## **DELEGATED REPORT**

FROM: Senior Planner FILE: OPW/21/0006

| APPLICATION           |  | PREMISES |                     |  |
|-----------------------|--|----------|---------------------|--|
| FILE NO:              | OPW/21/0006                                  | ADDRESS: | 2-4 Quill           |  |
| PROPOSED DEVELOPMENT: | Operational Works (Bulk Earthworks, Drainage |          |                     |  |

| Plan/Document<br>Number | Plan/Document Title   | Prepared by                 | Dated      |
|-------------------------|---|-----------------------------|------------|
| 160-001-C104 Rev B      | Grading Plan  | ERSCON Consulting Engineers | 15/04/2024 |

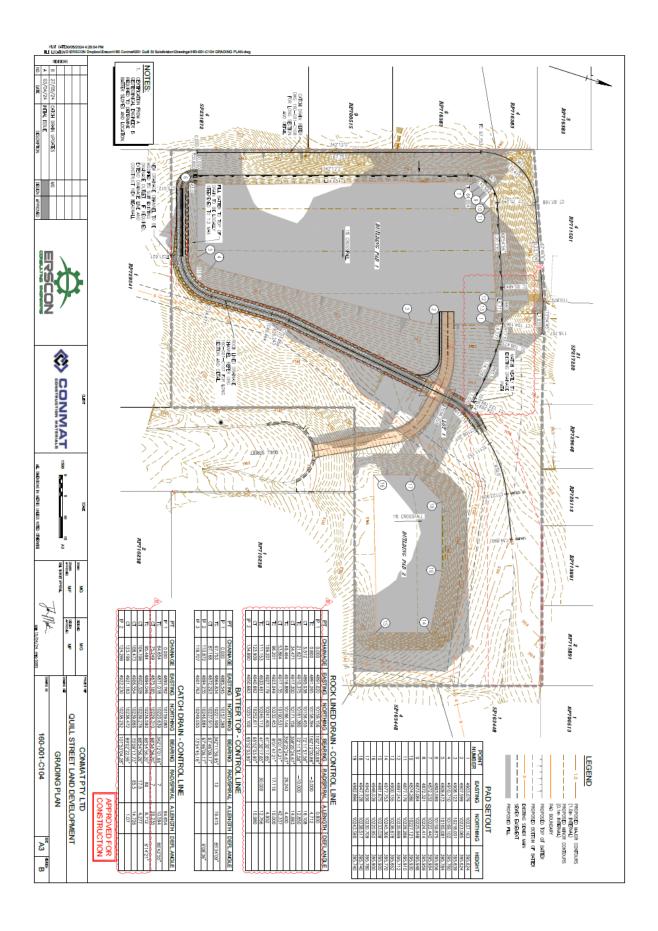
The drawings must be amended to show the location and extents of the existing drainage easement through the property overlaid on the General Layout Plan and site Grading Plan.

Prior to any filling works for Building Pad 1, the easement boundary and Building Pad boundaries are to be pegged on site and inspected with Council Officers.

No work is to occur within the existing easement without further approval from Council.

Council is prepared to consider the earthworks for Building Pad 1 as currently designed provided the easement is amended to include a commensurate footprint increase on the eastern side.

| Plan/Document<br>Number | Plan/Document Title   | Prepared by                 | Dated      |
|-------------------------|---|-----------------------------|------------|
| 160-001-C105 Rev A      | Driveway Plan   | ERSCON Consulting Engineers | 15/04/2024 |

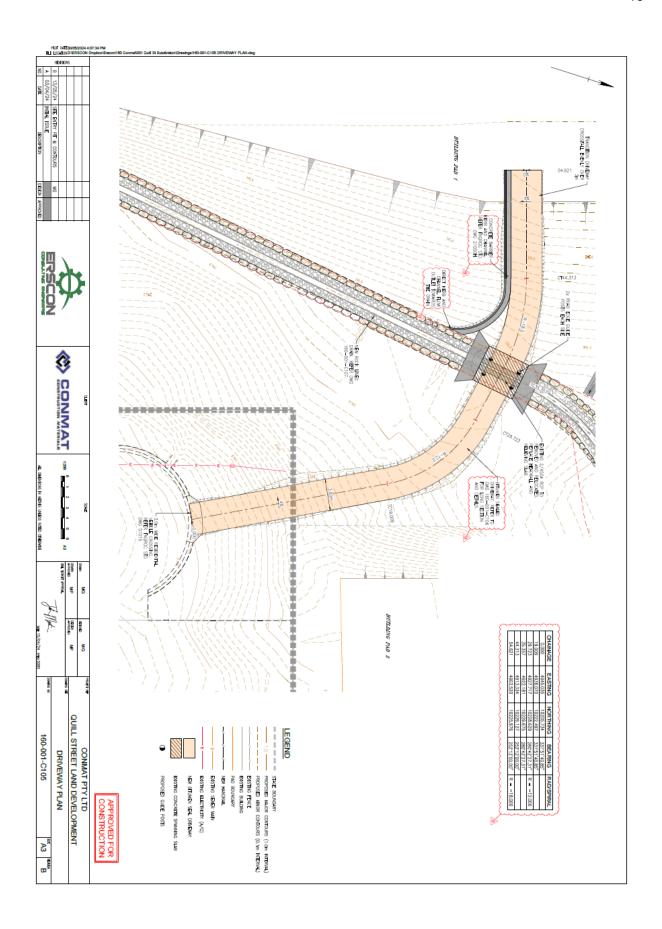
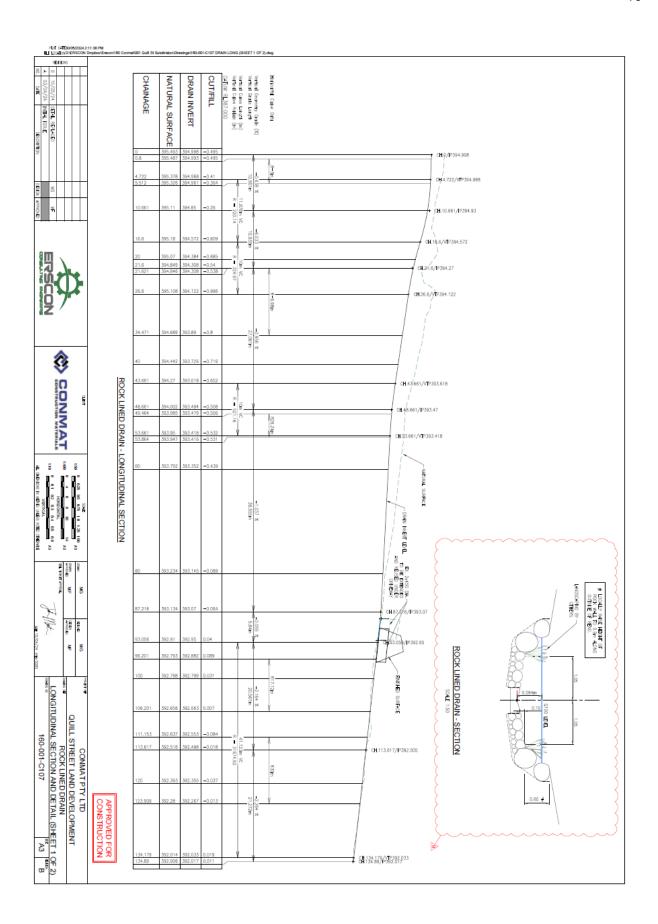
This Decision Notice approves construction of the driveway to Building Pad 1 in accordance with ERSCON Consulting Engineers Drawings 160-001-C105 and C106 Revision B.

The driveway approval is for the use of the site as a single lot only, and may not be supported for more intense use of the site where greater immunity for the driveway would be required.

The proposed driveway to Building Pad 1 does not achieve immunity or trafficability for the 1%AEP Flood Event for the Barron River, being inundated by approximately 1.8m. The driveway is considered suitable for single lot access only (noting Building Pad 2 accessibility during Barron River flooding). Any further development on the land must consider this flood immunity limitation of the driveway.

The proposed driveway access at Quill Street must ensure stormwater runoff in the Quill Street kerb line is not directed down the driveway to the drainage easement. The driveway crossover is to be regraded to have positive fall back to the kerb line and ensure runoff is directed to the existing kerb break west from the driveway.

The current driveway grading away from the kerb invert appears to accept runoff from the eastern kerb of Quill Street down the driveway.

The proposed driveway and driveway grades within Quill Street appear to grade from the kerb invert down into the site.

The applicant is advised that any intensification of the uses for this site may require the verge to be reconstructed to achieve a compliant verge grade for pedestrians, services, bin storage and car parking to service the additional demand from a new use.

If this is the design intent, the applicant must provide kerb and channel on the driveway from the Quill Street kerb line to the new rock lined drain in the existing drainage easement.

The driveway must also be included in a new easement for stormwater purposes reflecting its function to convey stormwater runoff from the road reserve to the existing drainage reserve.

The driveway may need to be considered to avoid the requirement for rework in the future.. Any changes proposed to the current driveway design must be provided prior to the Pre-start Meeting.

| Plan/Document<br>Number | Plan/Document Title   | Prepared by                 | Dated      |
|-------------------------|---|-----------------------------|------------|
| 160-001-C108 Rev B      | Catch Drain Longitudinal Section and Detail (Sheet 2 of 2)      | ERSCON Consulting Engineers | 15/04/2024 |

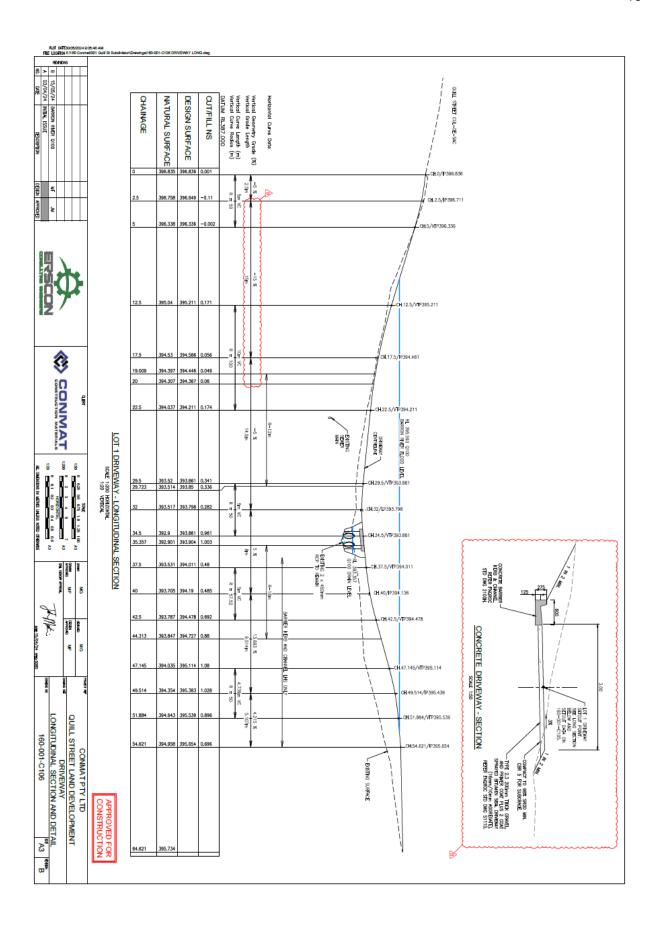
The final location of the catch drains on the northern and western sides of Building Pad 1, will be subject to confirmation of the batter profile by the site-specific geotechnical report.

The applicant must not construct the drains prior to Council's written confirmation that the Geotechnical Report has been accepted.

Concrete lining of the catch drain must be provided in accordance with the detail on ERSCON Consulting Engineers drawing number 160-001-C108 Revision B for the full extent of the catch drains on the northern and western sides of Building Pad 1.

The Construction Issue Drawings must be amended to reflect the drain lining requirement and provided prior to the Pre-start Meeting.
